Item Name: Aft Facing Seat Assembly, LH

**D412-769-043 AFT FACING SEAT ASSY, LH**

DRAWING NO. D412-769-1	TITLE AFT FACING SEAT ASSY, LH	REV. B	DART AEROSPACE LTD ENGINEERING ORDER		D.E.O. NO. D412-769-1-B-1	SHEET NO. SHEET 1 OF 2	SCALE NTS
DRAWN	CHECKED <i>UP</i>	MFG. APPR. <i>[Signature]</i>	APPROVED <i>[Signature]</i>	DE APPR. <i>[Signature]</i>			
DATE 12.07.09	DATE 12/7/10	DATE 12.07.10	DATE 12.07.10	DATE 12.07.10

ADDITION OF QTY(2) D4679-1 SPACER PER PAR12-207.

**DETAIL L**  
**SEAT BOTTOM ATTACH - FRONT DETAIL**  
2 PL

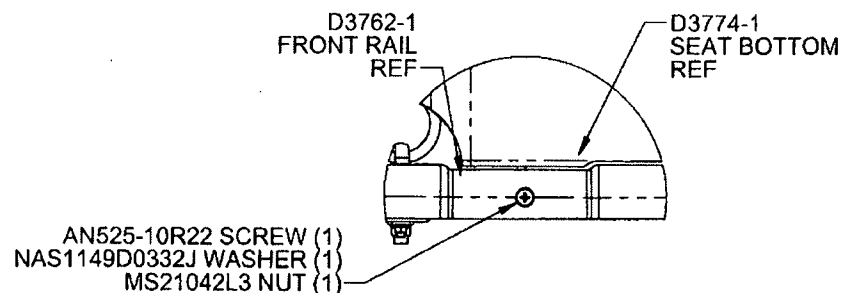
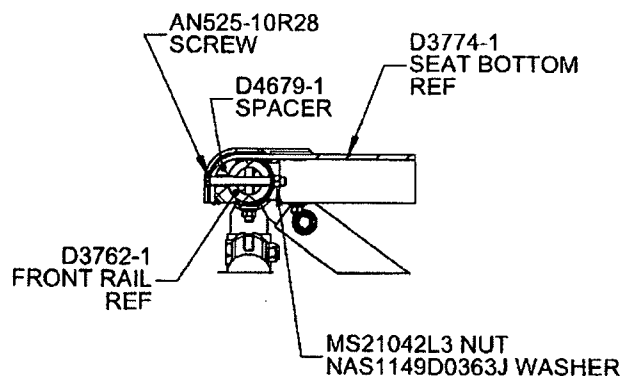
IS:

WAS:

**SECTION P-P**  
**INSTALLATION OF D4679-1 SPACER**  
2 PL
